MEMORANDUM

SUBJECT: Township of Woodhouse
Proposed Bridge over Black Creek,
Con. IV, Lots 18/19
County of Norfolk
Structure Site No. 21-85
Our File No. BA 1591

Attached please find one copy of the Foundation Report, by William A. Trow and Associates Ltd., and one copy of the Final Plans for your comments.

Dr. C. M. Arnold
DESIGN ENGINEER
Dwg. No. E 3643

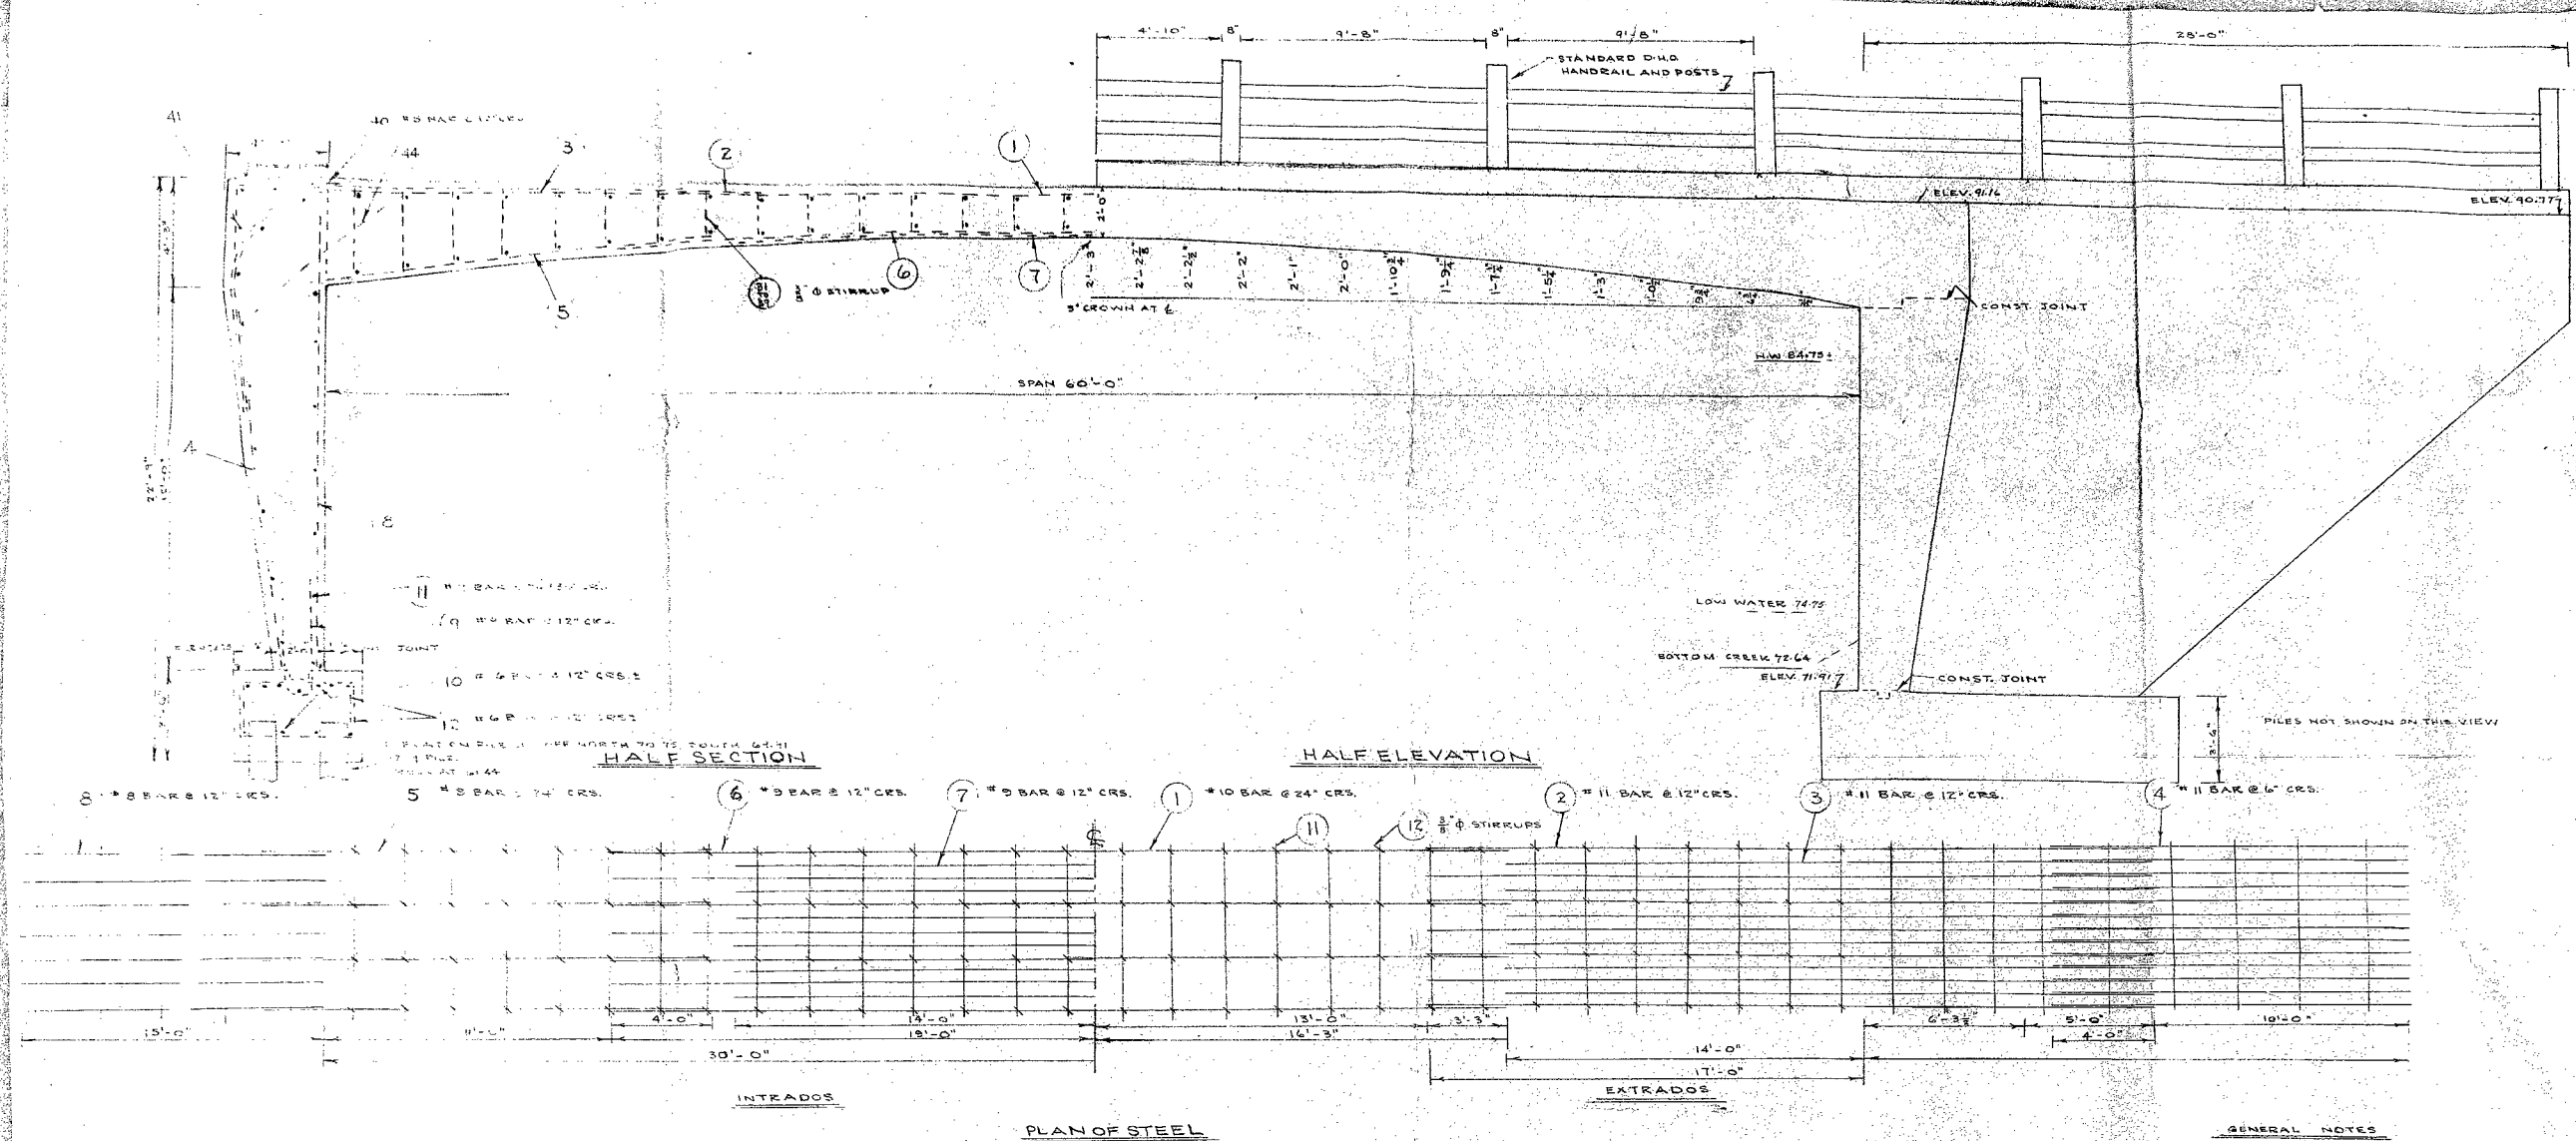
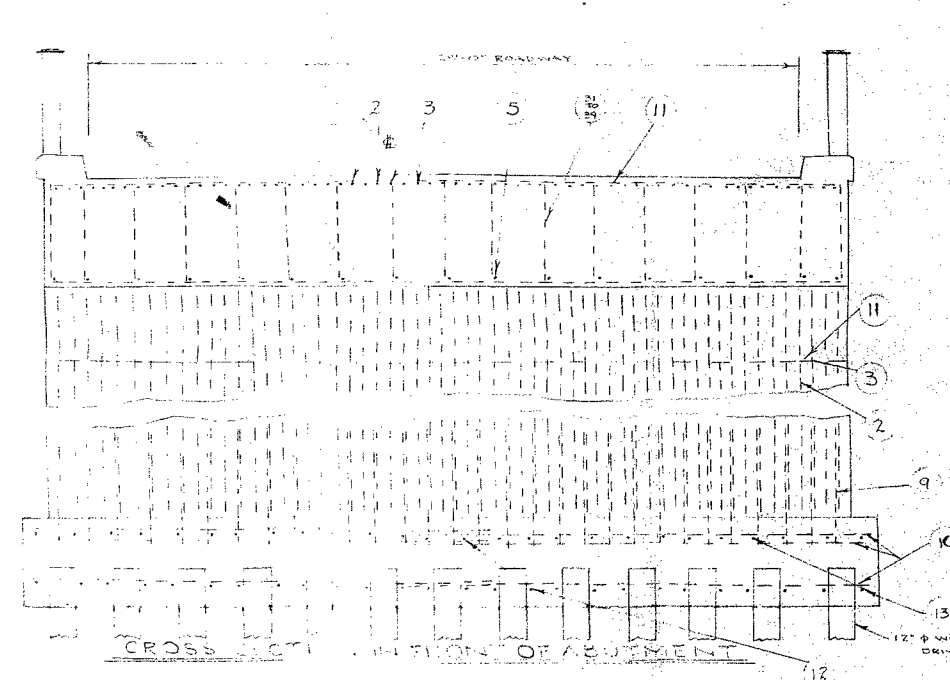
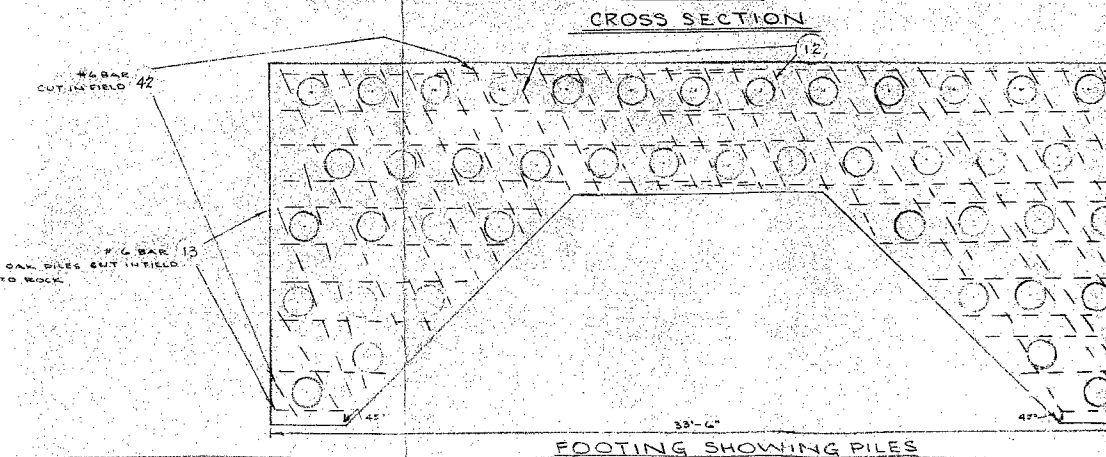
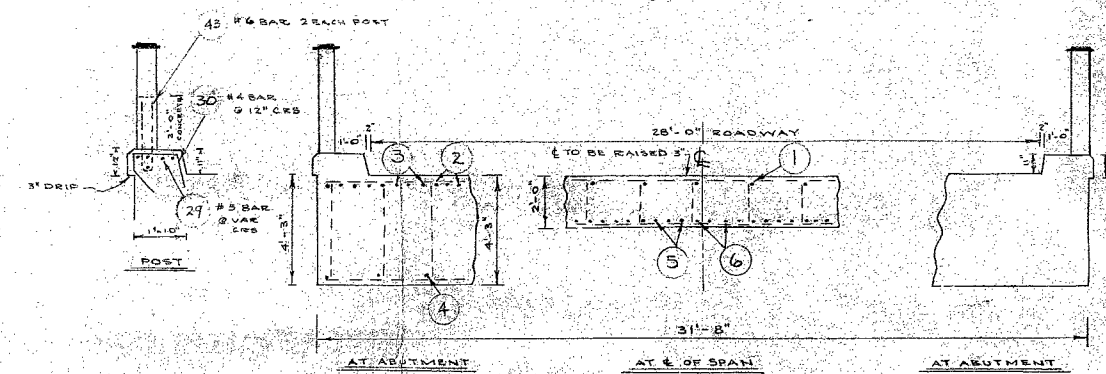
*Basically no comment.
Soil consultant suggests scour protection -
no measure is shown on bridge drawing.
He do not comment on scour possibility,
just mention the above fact.
By phone to G.C.E.B.*
